The Town of Hilton Head Island  
**Design Review Board Special Meeting**  
**Friday, May 29, 2020 – 9:00 a.m.**  
**AGENDA**

**Subject:** *Harris Teeter Fuel Center #423 – Sea Pines  
Response to DRB Review Comments*

We are writing in response to the comments made on the site plans for the Harris Teeter Fuel Center #423 on January 14, 2020.

C2-1

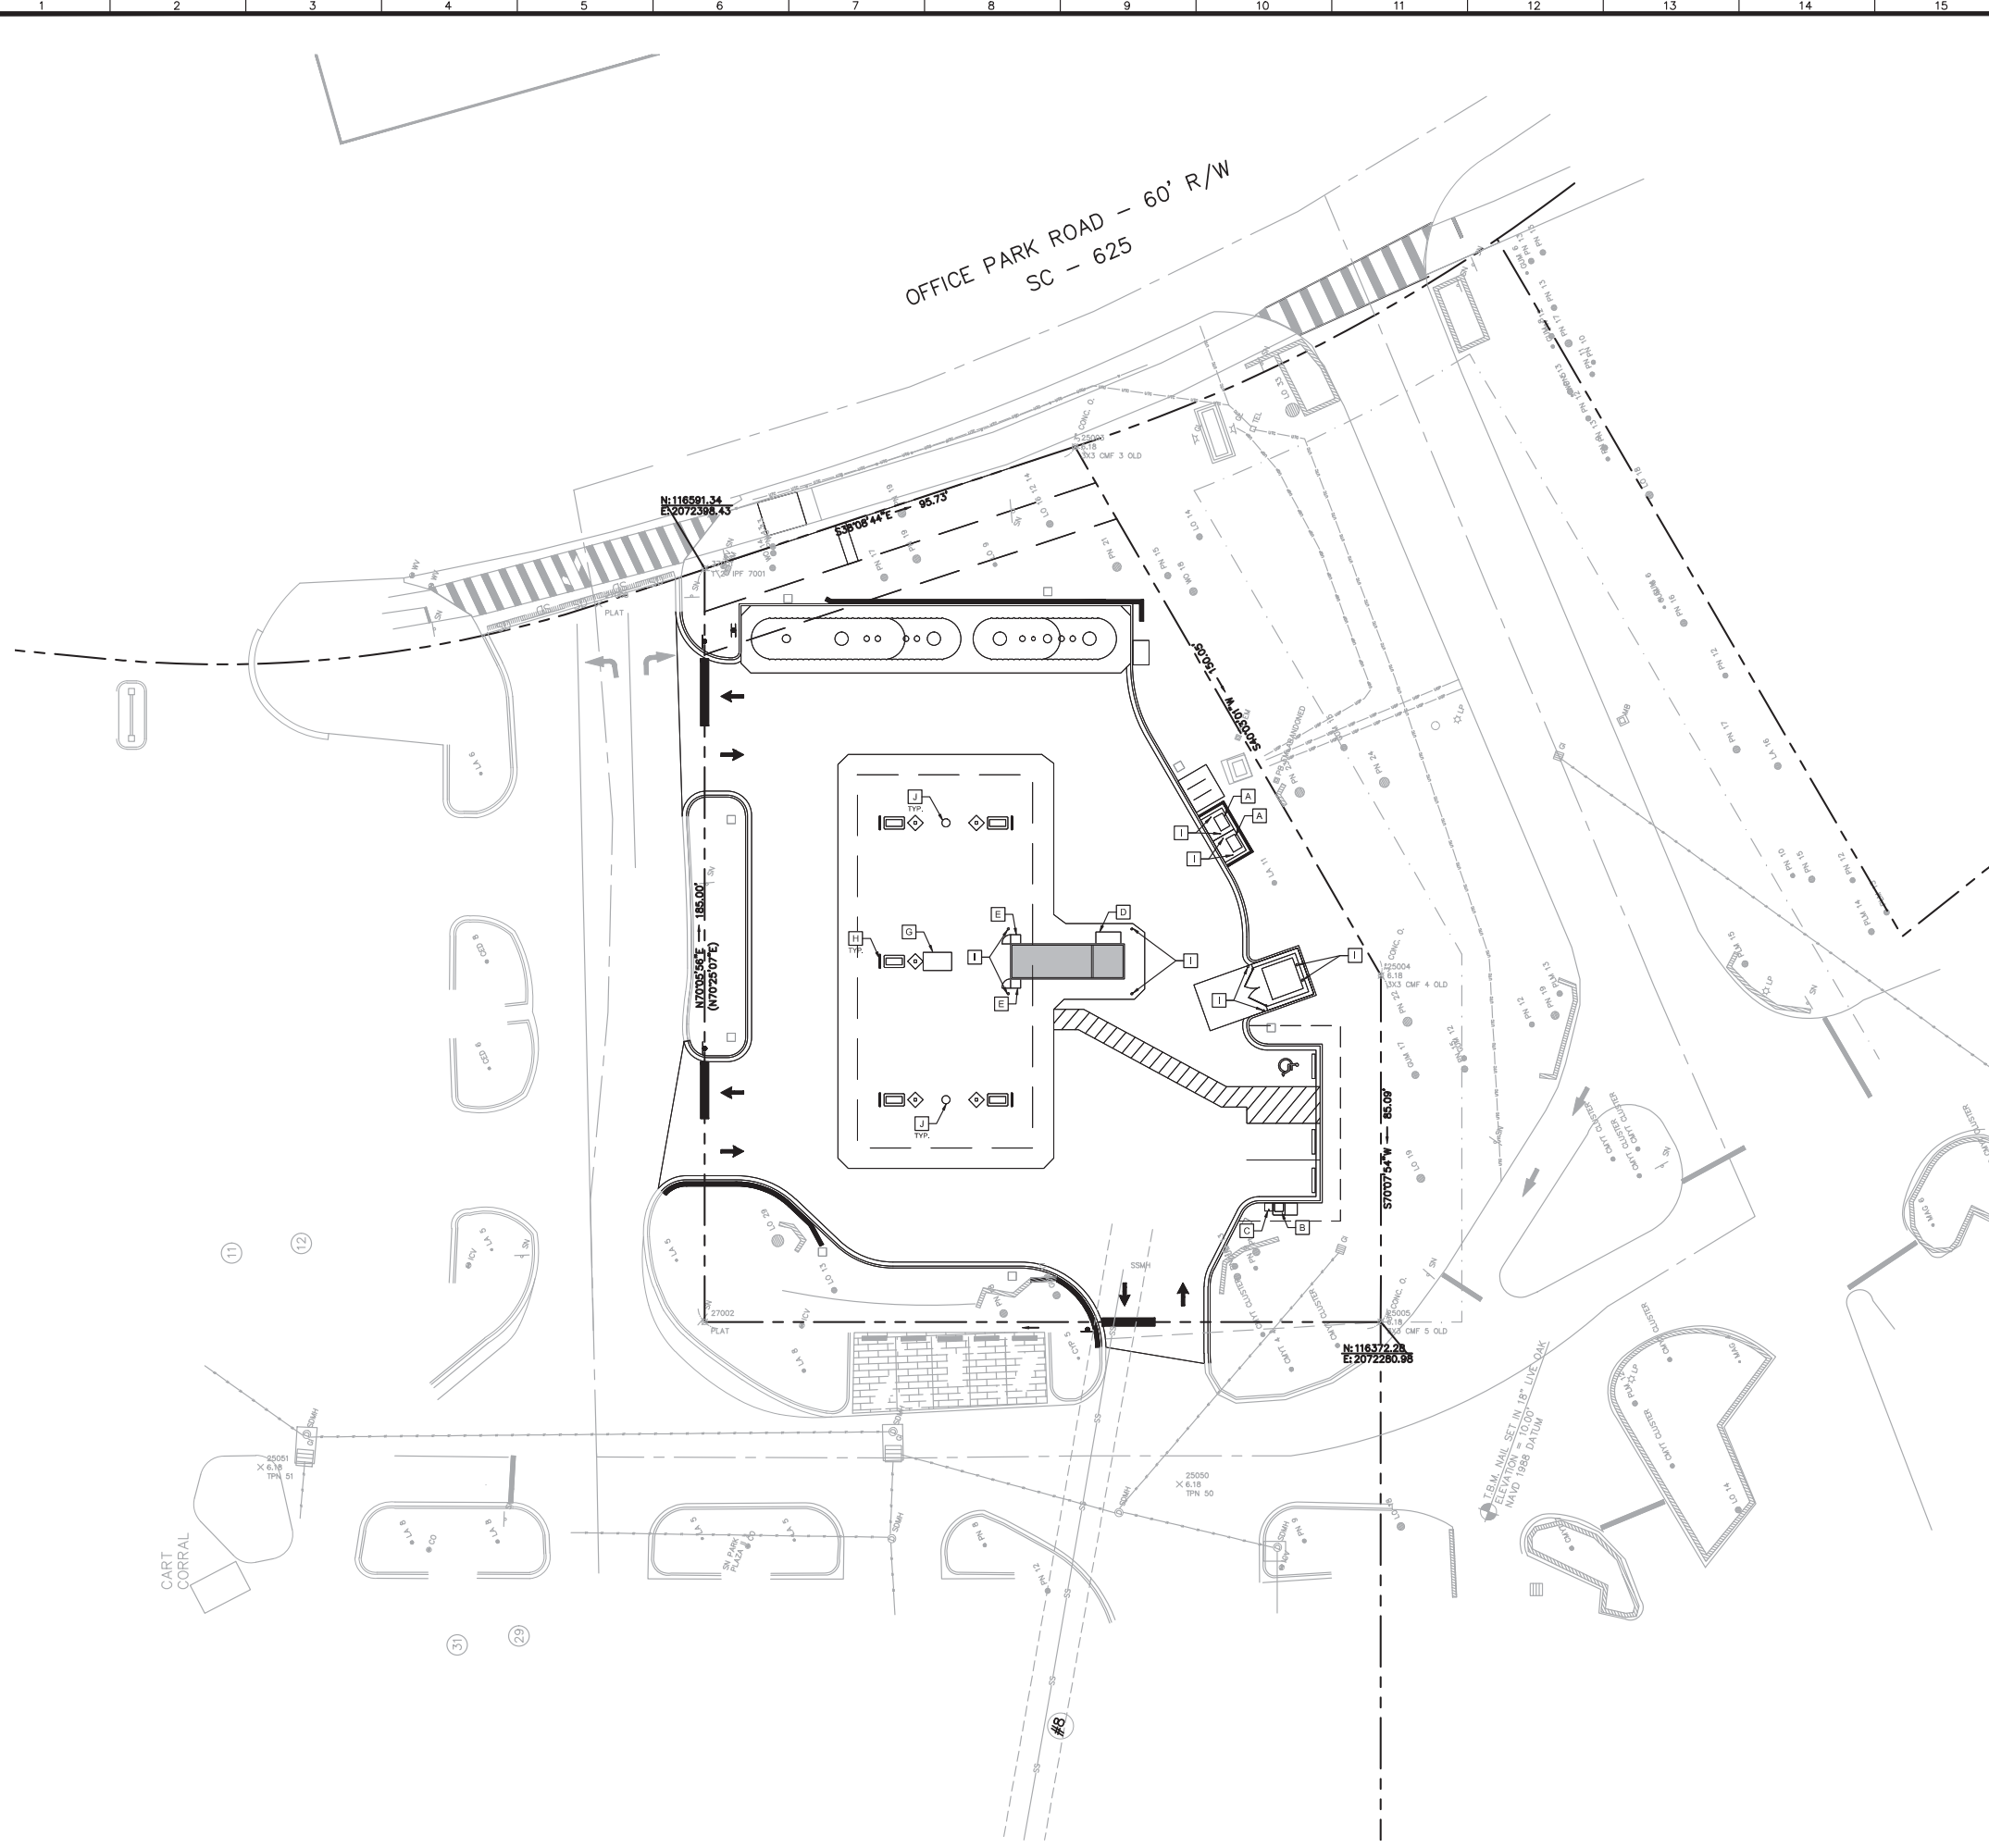
4. Blue Rhino cages should be screened. Staff suggest the applicant consider locating cages adjacent to dumpster enclosure.

**Response:** *A brick enclosure has been added for the Blue Rhino cages. Please see Sheet C2-1 Fuel Station Site Plan. The grades adjacent to the dumpster enclosure are at a 3:1 slope to avoid disturbing the 11" Laurel Oak; therefore, the cages have been placed further away to allow for them to remain on a flatter slope.*

**Response:** *The bollards onsite have been specified to meet the same bollards at the existing Harris Teeter grocery store. Please see Sheet C2-1 Fuel Station Site Plan and Sheet C6-3 Site Details.*

C2-3

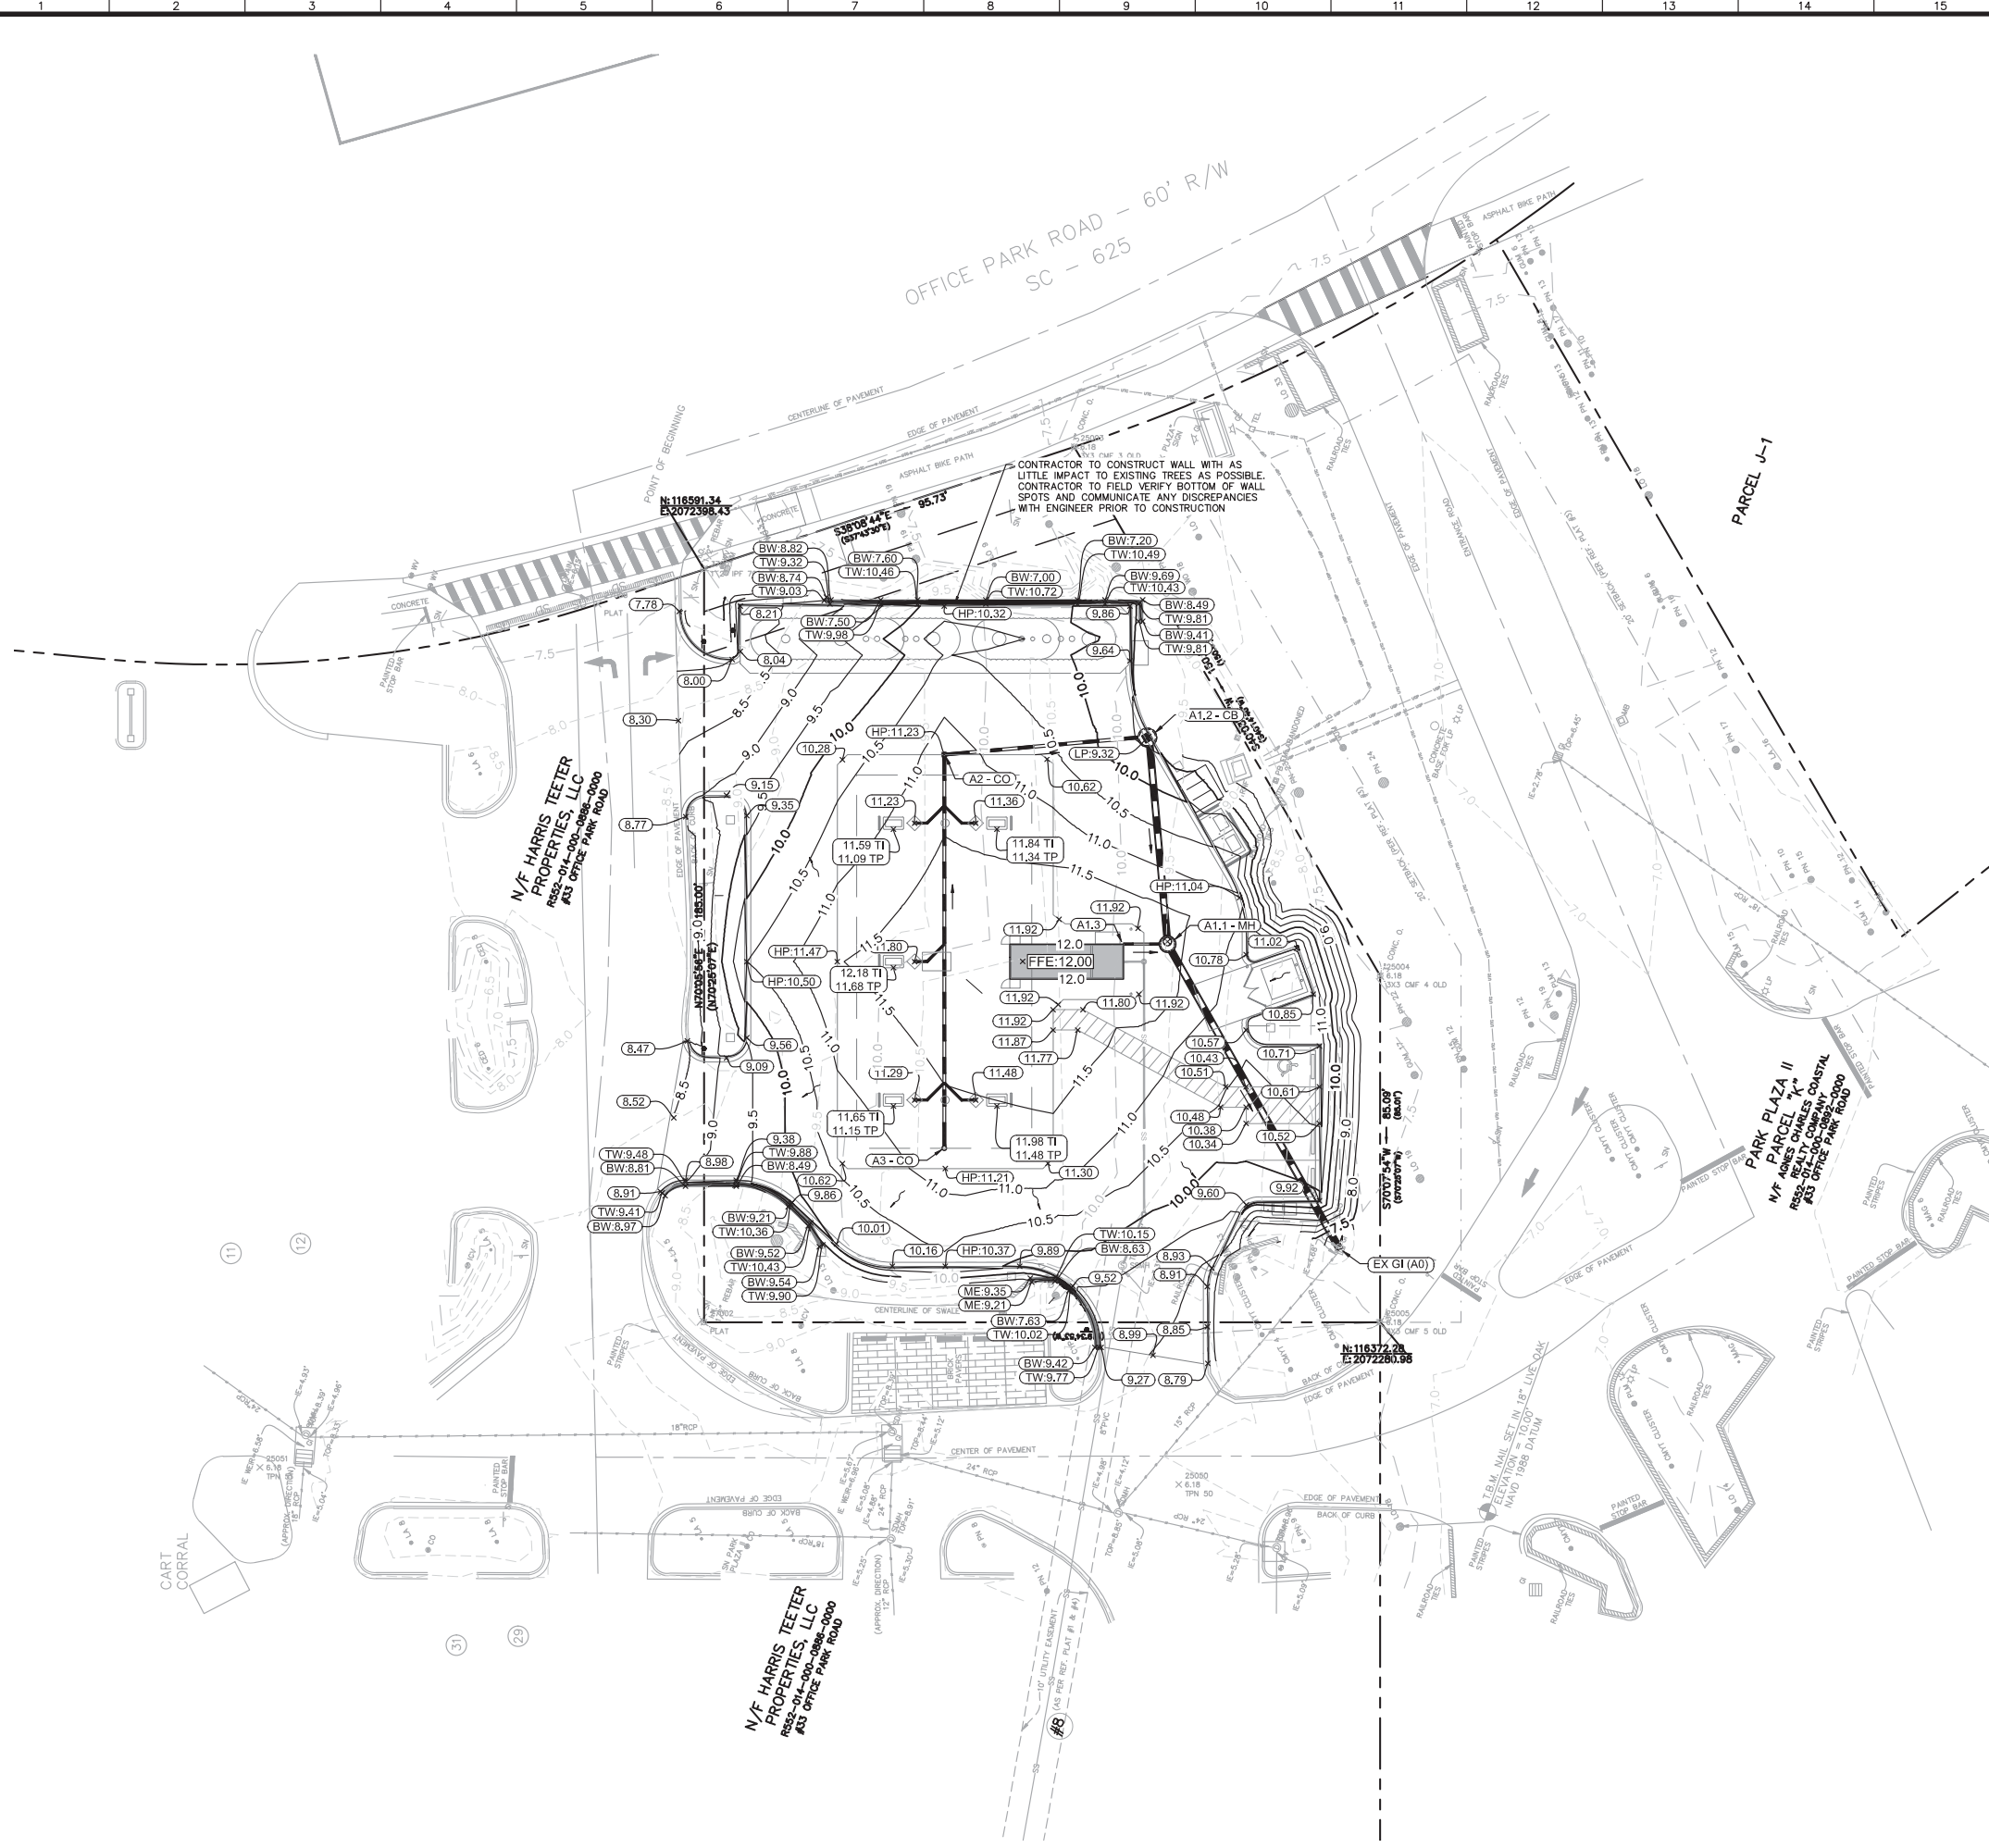
7. Only two glass door merchandising units are shown on the elevation and four on the Fixture Plan (sheet C2-3, items E & F)

**Response:** Sheet C2-3 Fuel Station Fixture Plan has been updated to show the correct 2 glass door merchandising units shown on either side of the kiosk.

**Response:** The waste receptacles on site will be black. Please see Sheet C2-3 Fuel Station Fixture Plan callout J.
